**Planning Board Meeting Agenda
Brunswick Town Hall
85 Union Street – Council Chambers
Tuesday, February 10, 2026 @ 6:00 PM**

DRAFT FINDINGS OF FACT SITE PLAN AMENDMENT PLANNING BOARD

MAINEHEALTH
MID COAST CANCER CENTER RENOVATION
81 Medical Center Drive
Brunswick, ME 04011

1 FLOOR PLAN - 81 LEVEL 1 - LINEAR ACCELERATOR
A1.25 1/4" = 1'-0"

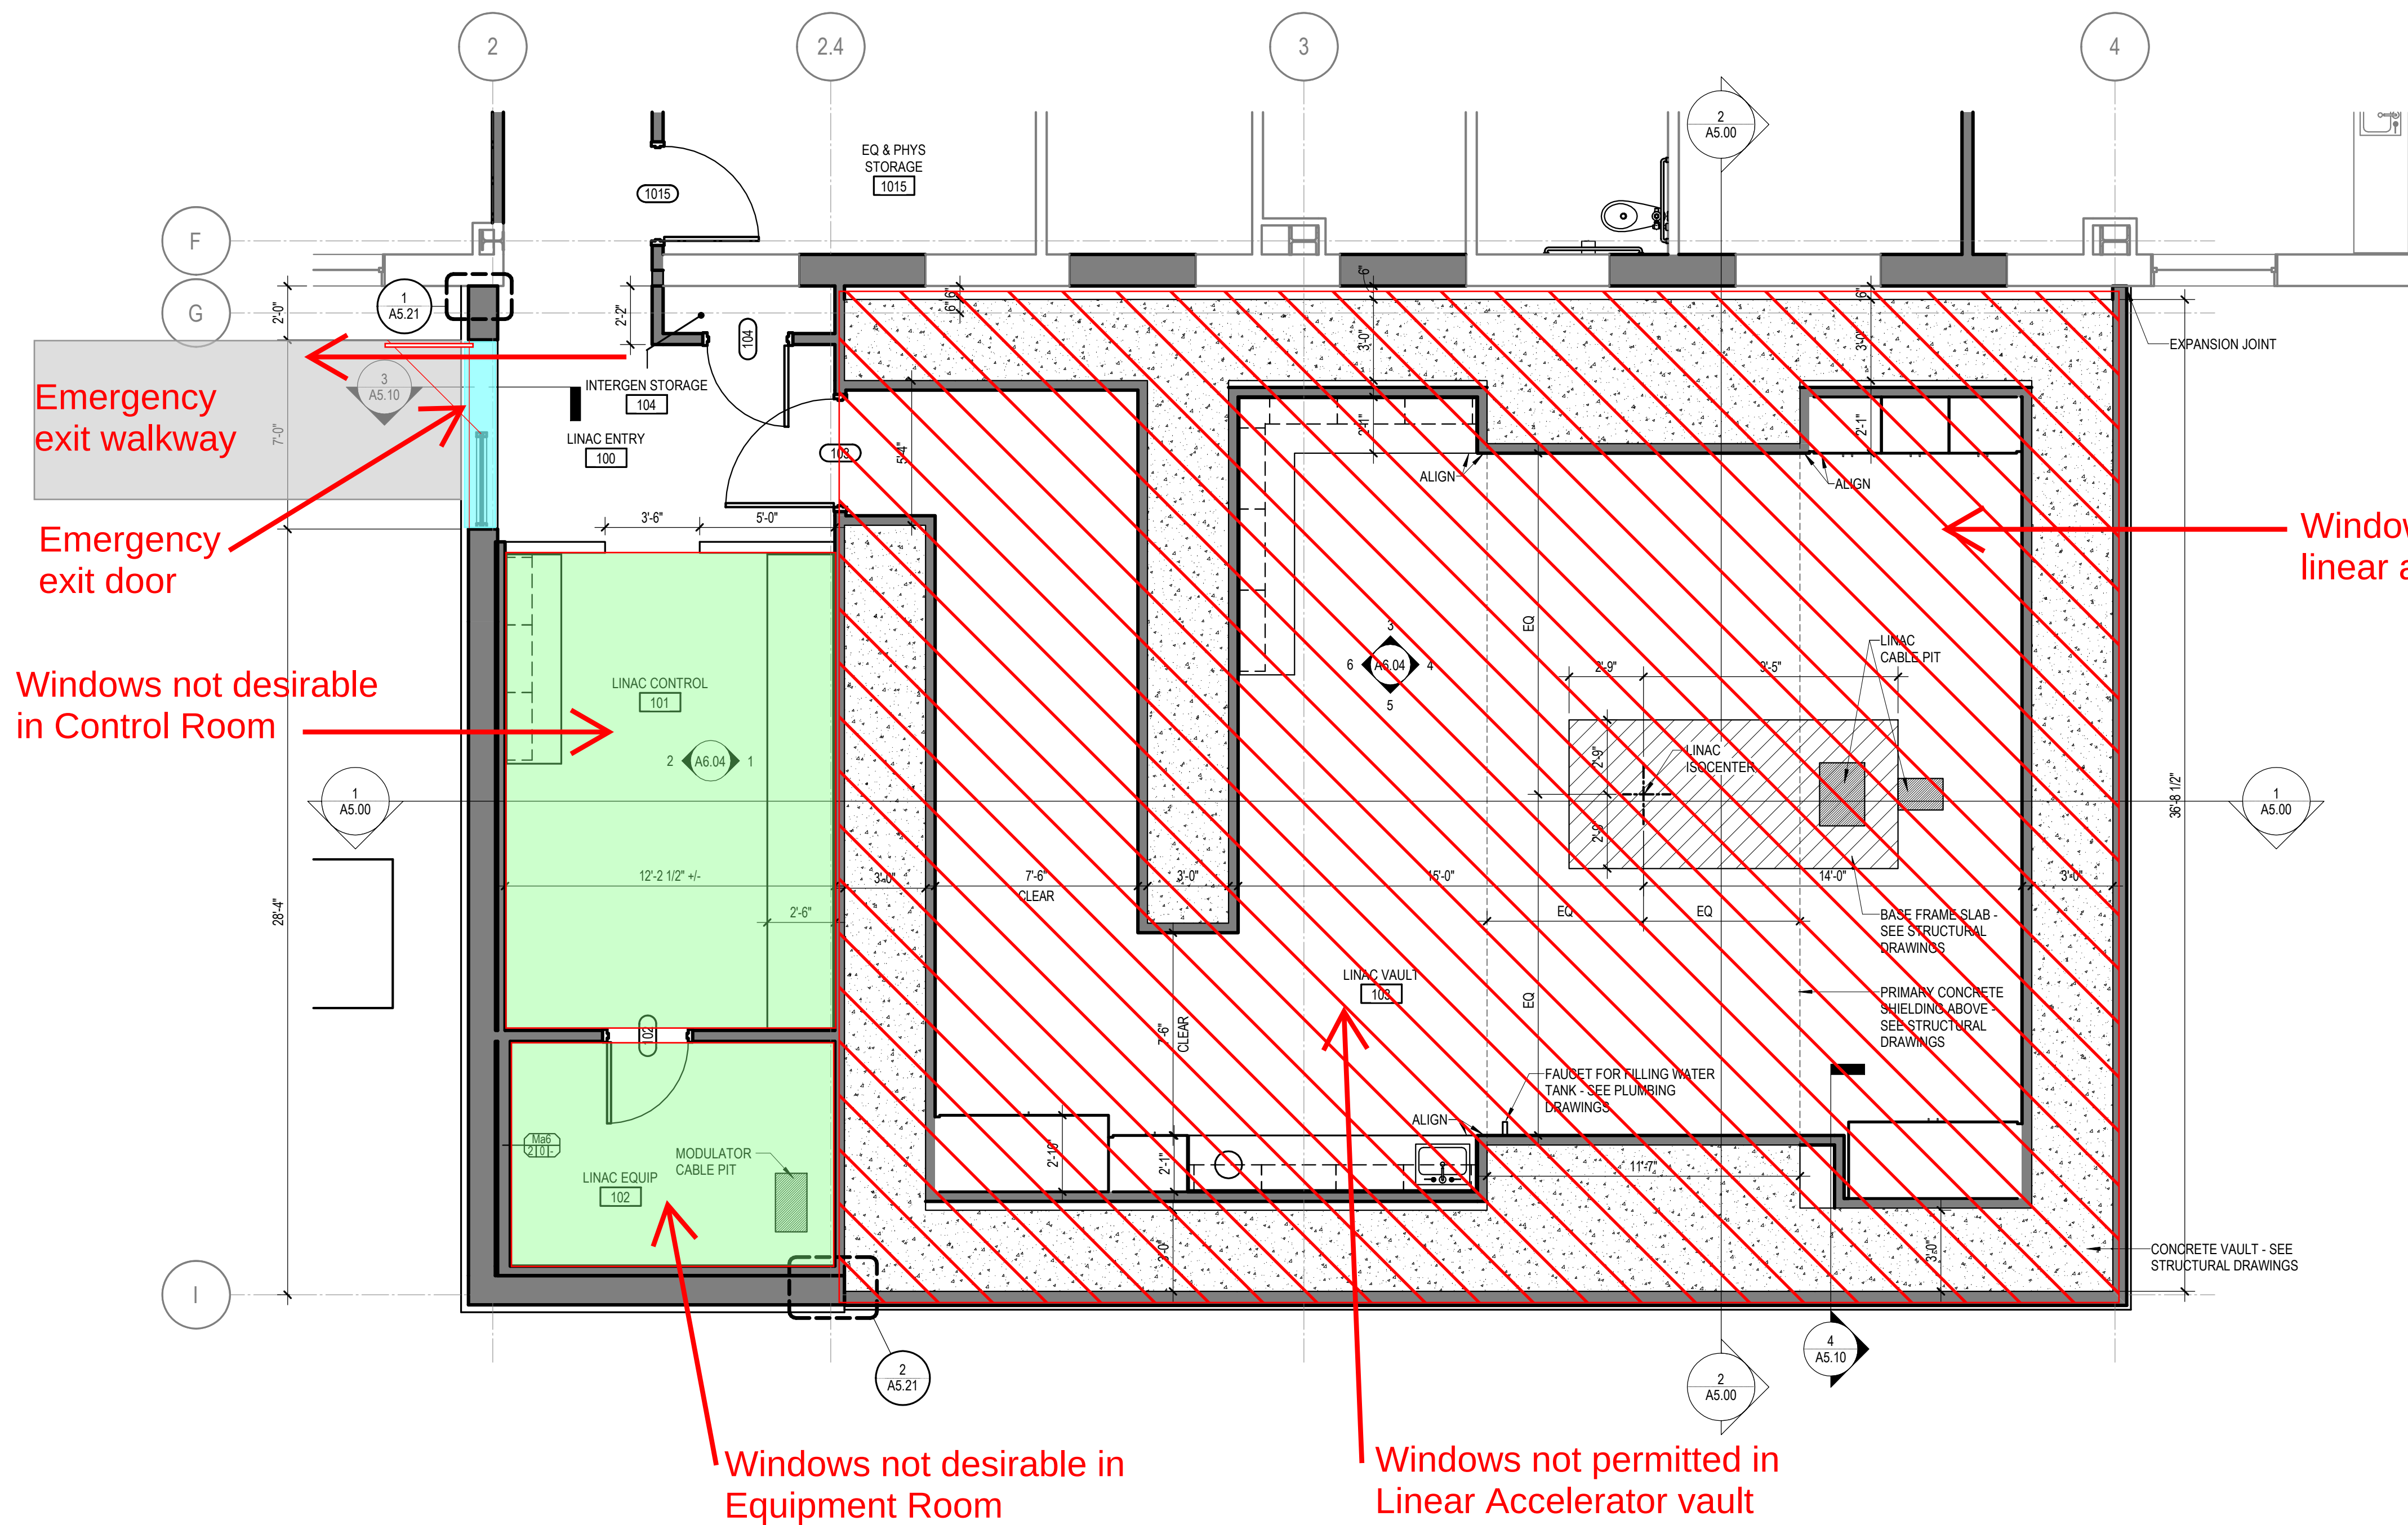
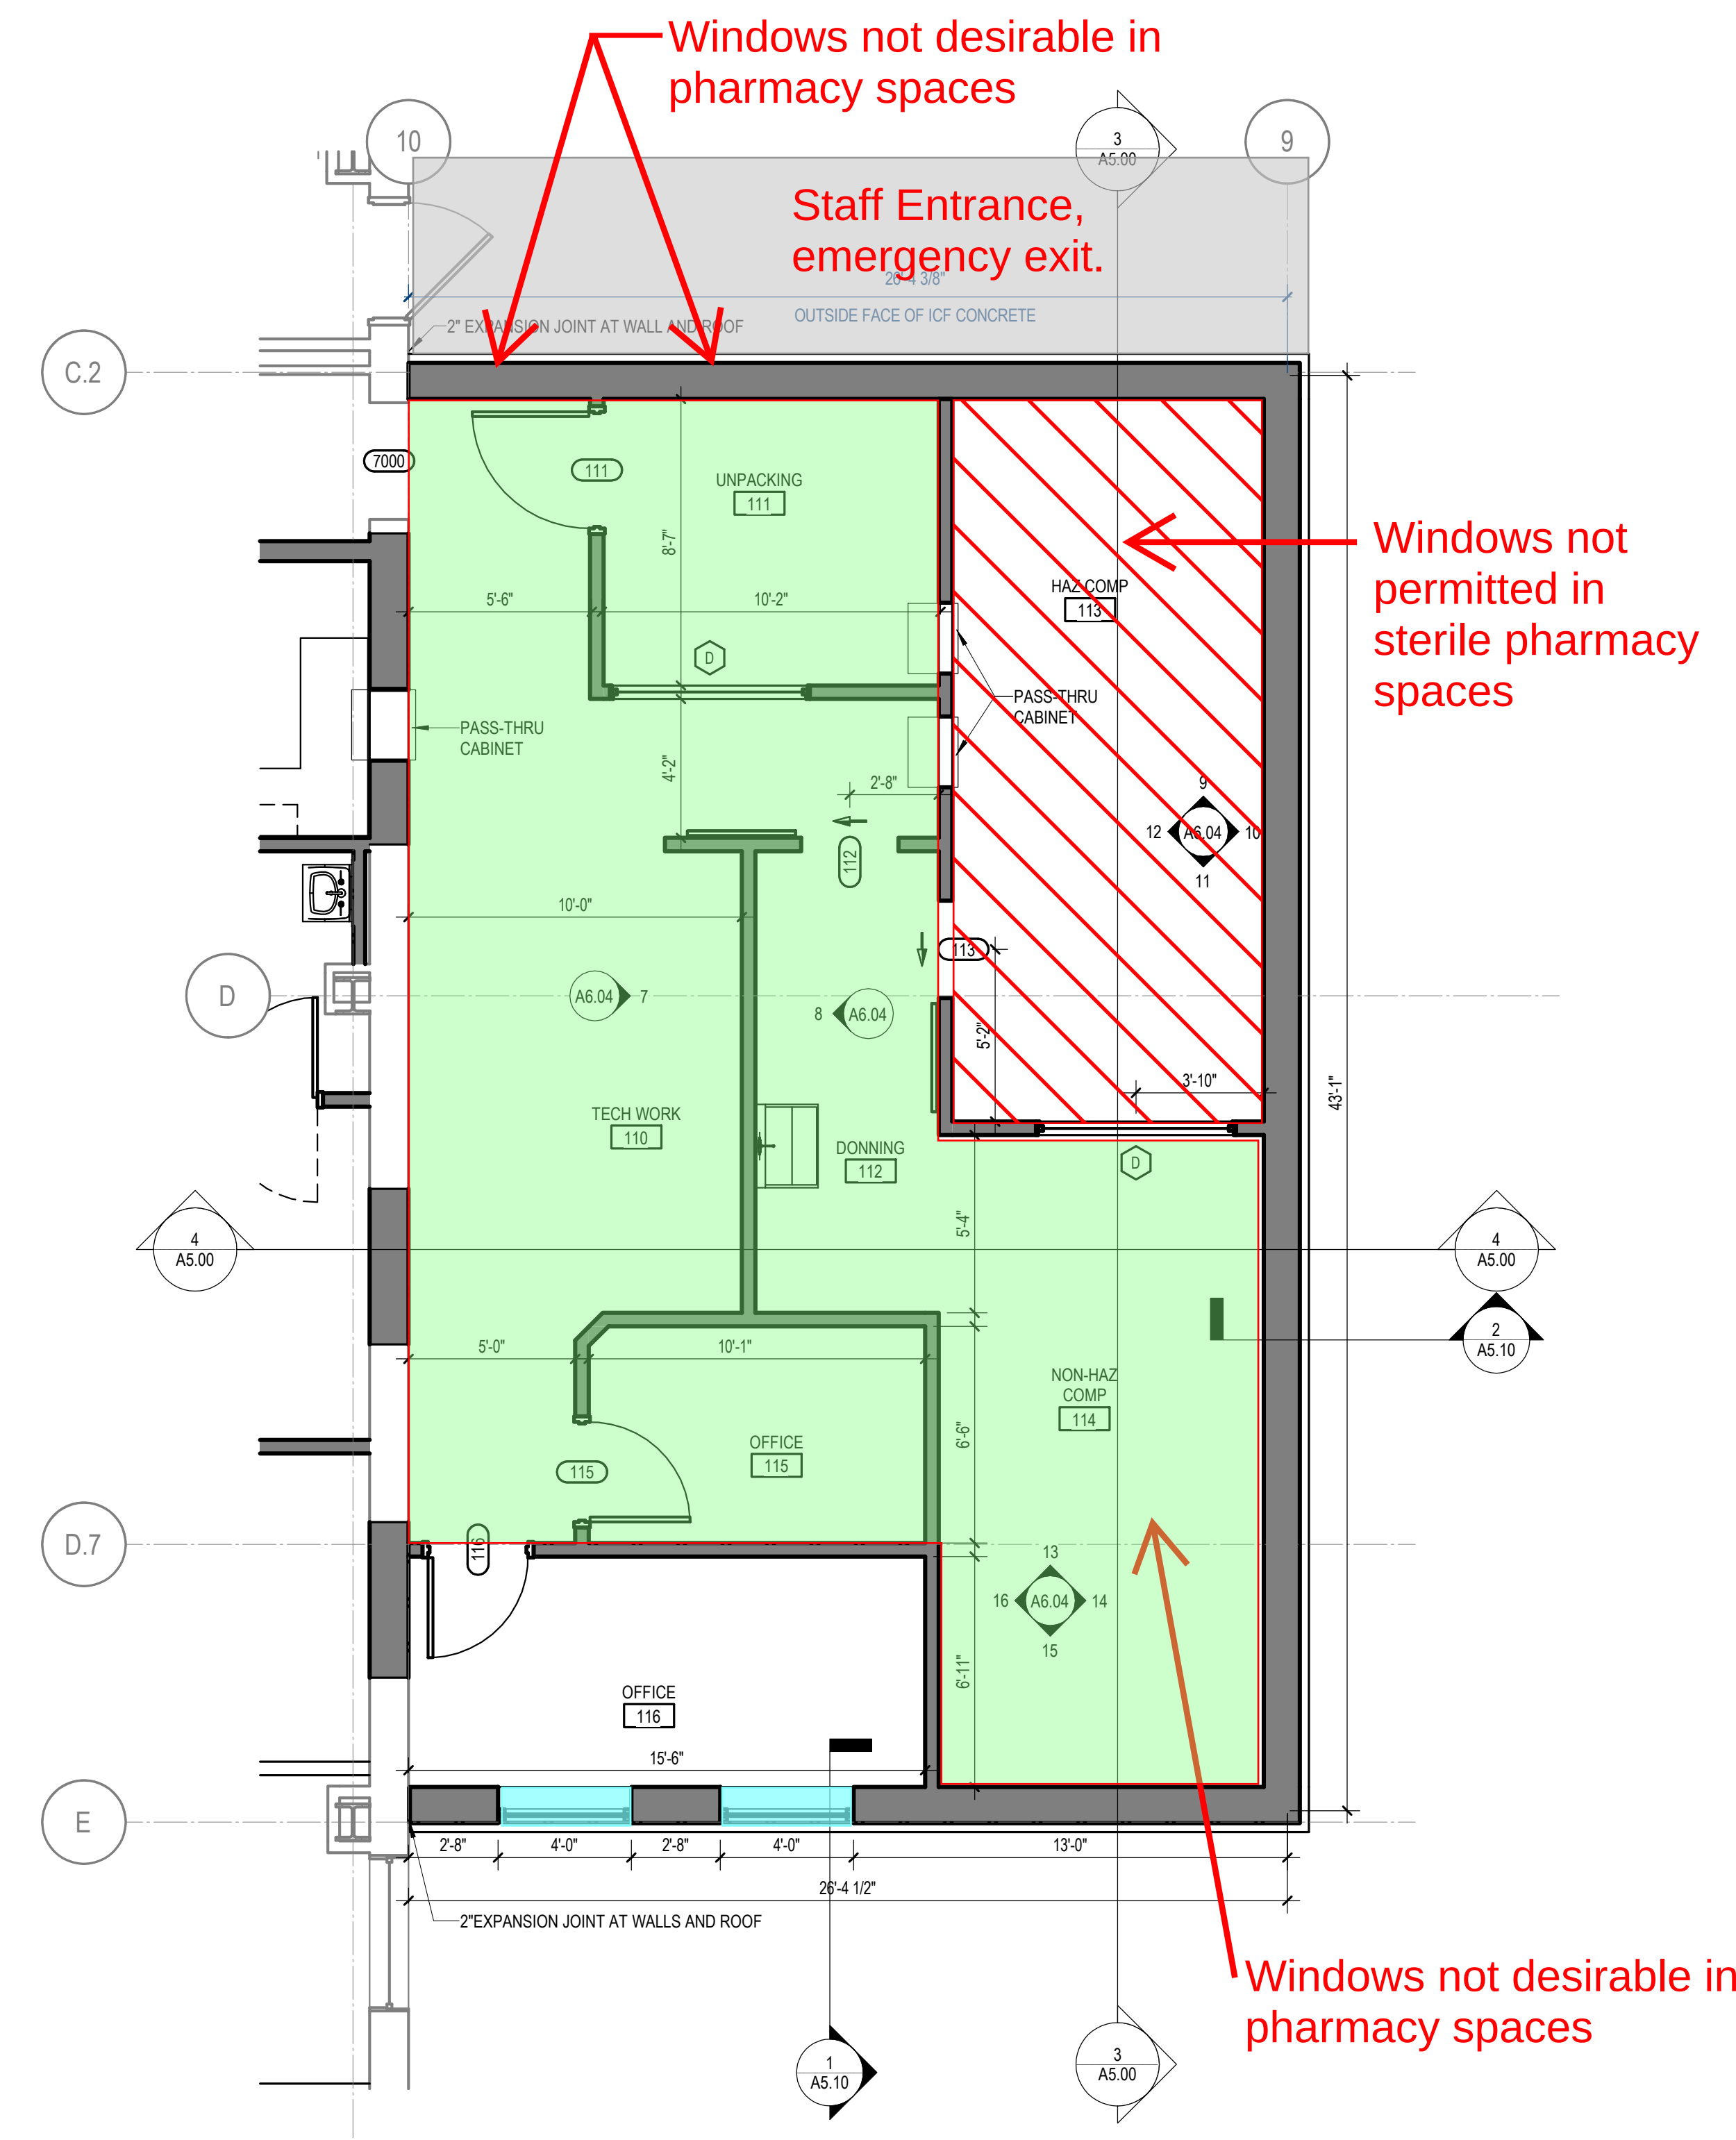
Julie: Would you, at least with the pharmacy portion, be able to add some plantings along that windowless facade to kind of to break up that wall? **Jon:** On the pharmacy, on the lower left-hand corner where we see the two small windows. That's the only face that we could do plantings on the opposite side, which is over here on the other small elevation, that's the sidewalk entrance into the back of the building. There's literally no place to put plantings without reconfiguring that staff entrance, which is also an exit access way. And then the long face of the building that's facing us in the middle is literally about 18 inches from the edge of the drive lane of the parking lot. Again, there's no opportunity there. We could put some plantings on the street facing side of the of the linear accelerator, which would be the top image with the window.
